- (1) Willis Side Road, Underpass, Plan #D-6170-F1,
N.P. 59-59, Site #5-47, N.C. Freeway, Dist. #2.
 - (2) Coyne Road, Underpass, Plan #D-6169-F1,
N.P. 57-59, Site #5-125, N.C. Freeway, Dist. #2. ✓ 511
-

We have reviewed the above mentioned Preliminary Bridge Plans with regard to the structure foundations. Our comments which apply to both structures, are as follows:

Coyne Road Underpass
4.7 Miles East of Hwy. #76
W.P. 57-59, Site 5-125
M.C. Freeway (401), District 2

Re: Dunwich Twp. Bridge #12,
Hwy. 401 -- District #2,
W.P. 57-59
W.J. F 59-94.

GENERAL LAYOUT

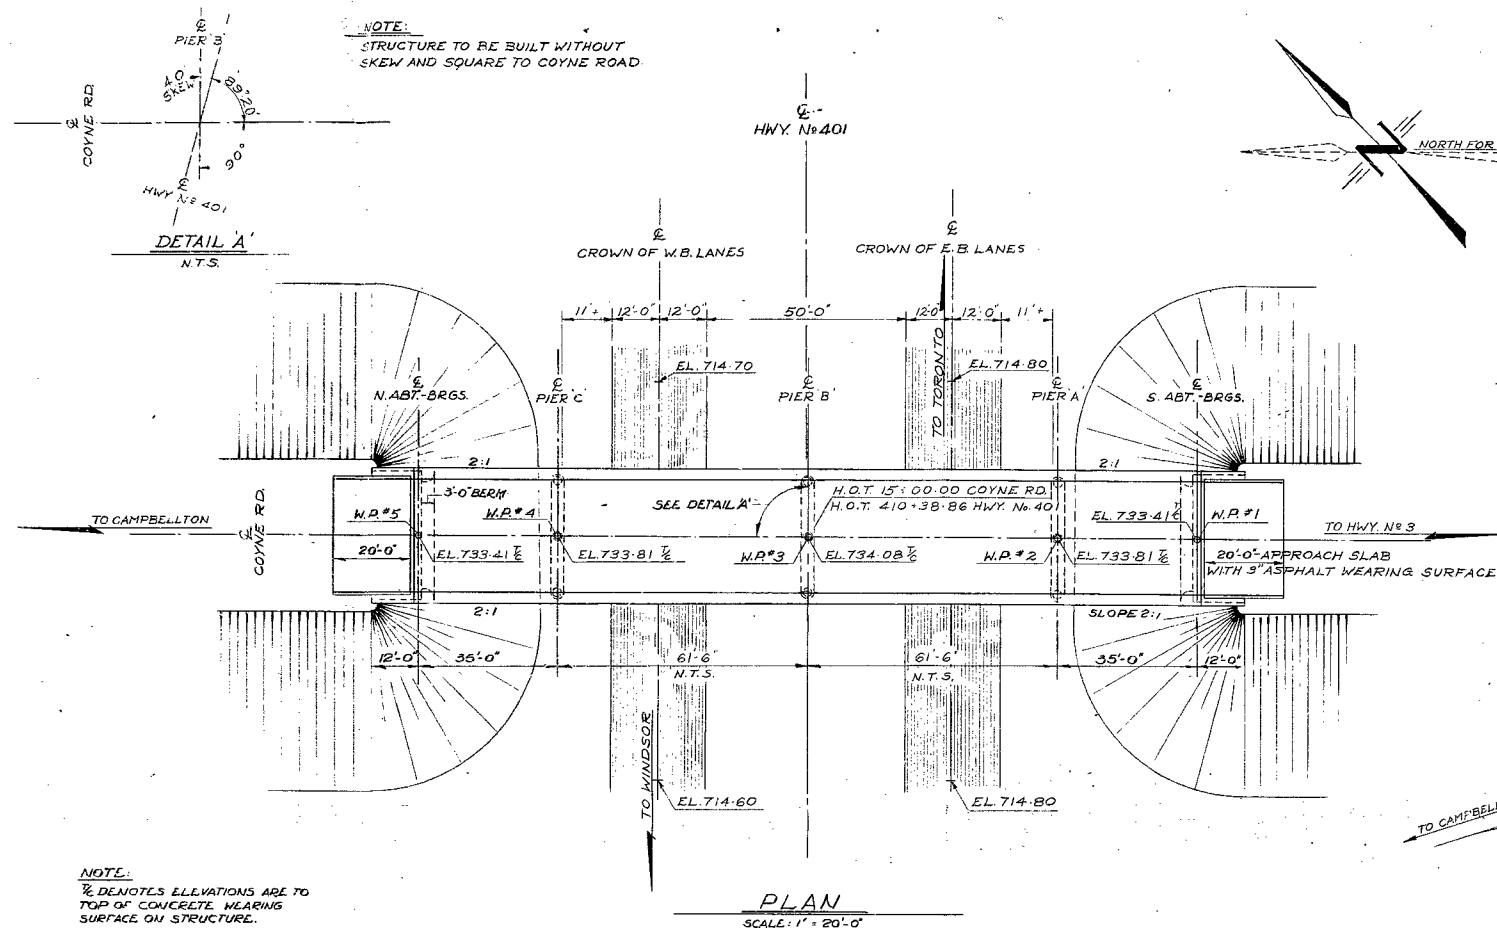
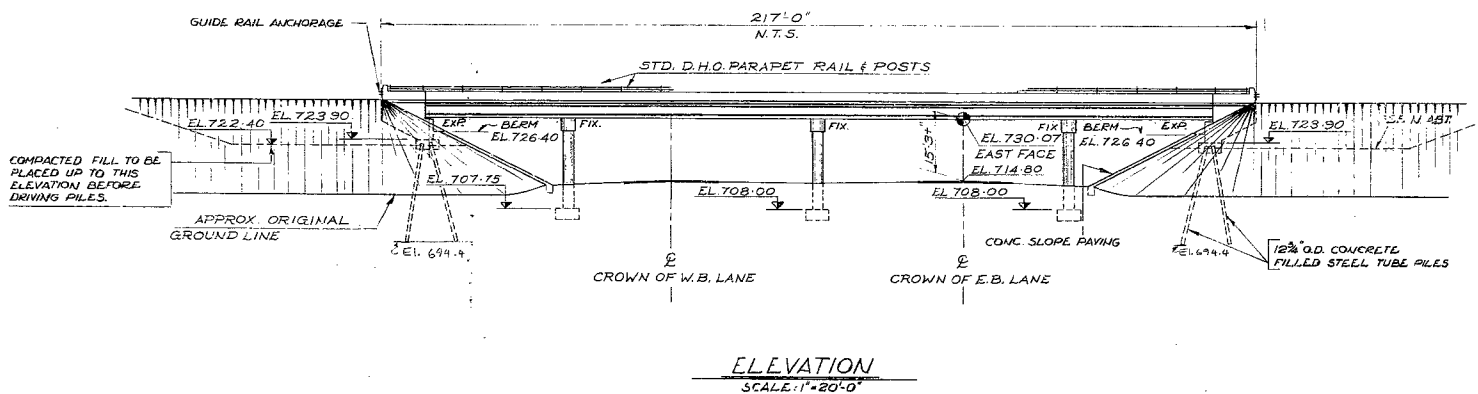
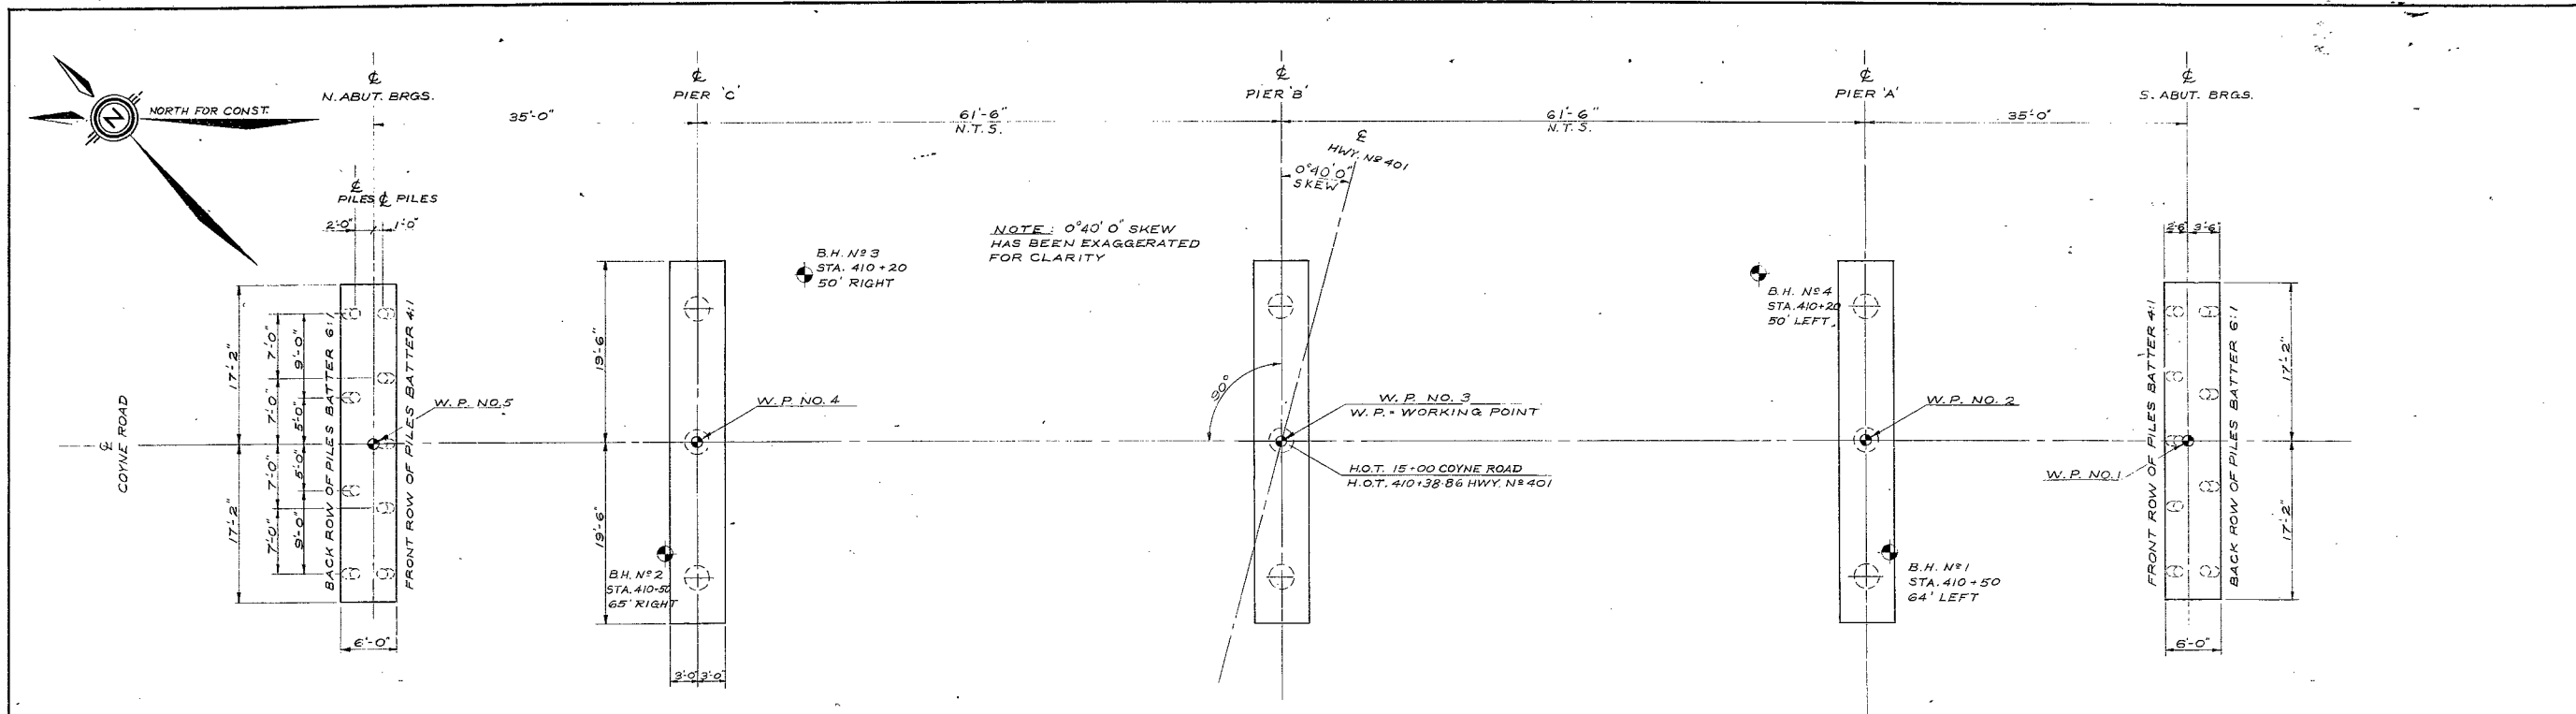
(1) In general, the designer appears to have complied with the recommendations contained in the foundation reports.

(2) Beneath the abutments the fill should consist of well compacted granular material. Prior to placing this fill, all topsoil and soft material should be removed over an area at least twice as large as the abutment footings.

(3) In order to facilitate pile driving, it is recommended that the fill below the abutments be screened to exclude all grain-sizes larger than 3 inches.

(4) We intend to carry out some pile loading tests at a nearby structure site. The results of these tests may prompt us to revise our recommendations pertaining to the safe capacities of the piles at this structure.

FOUNDATION LAYOUT

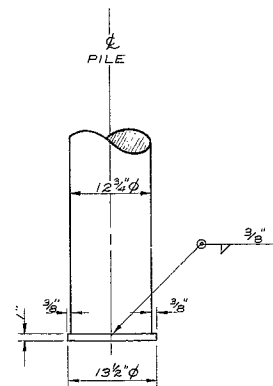
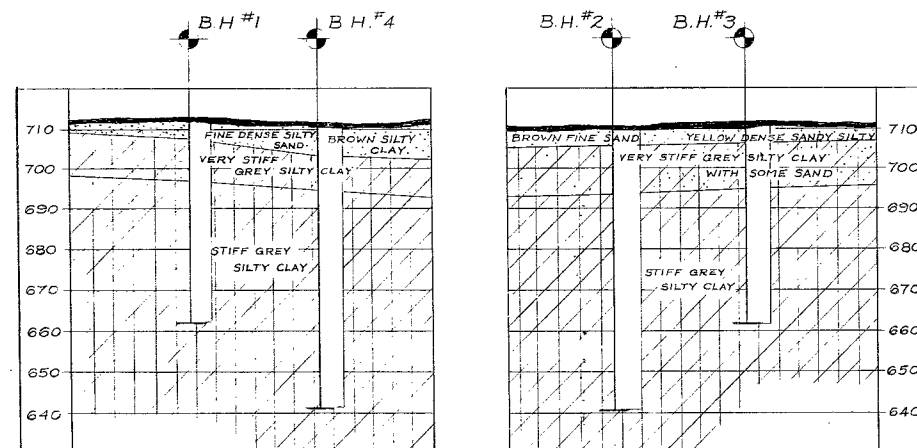
A review of the Preliminary Bridge plan for the above structure indicates that steel 'H' piles are proposed as support for the bridge abutments. As has been indicated for other structures in this area (W.P. 58-59) these steel 'H' piles are not the best type of pile to select. The foundation report prepared by this Section indicates a deep deposit of stiff clay. This clay will not provide end bearing for 'H' piles; thus, the 'H' piles are frequently driven to deep depths. For this reason, this Section recommends the use of steel tube piles.

For the structure in question, if steel 'H' piles are a must, these piles should be driven to approx. elevation 680.0' and then tested by a pile loading test. The pile load test will determine the safe load-carrying capacity of these piles. An estimate of this pile capacity is 30 to 40 tons.

An alternative to steel 'H' piles, and the method recommended by the Foundation Section, is steel tube piles. Steel tube piles designed to carry a load of 40 tons/pile will meet refusal to driving at approx. elevation 696 \pm 5 ft.
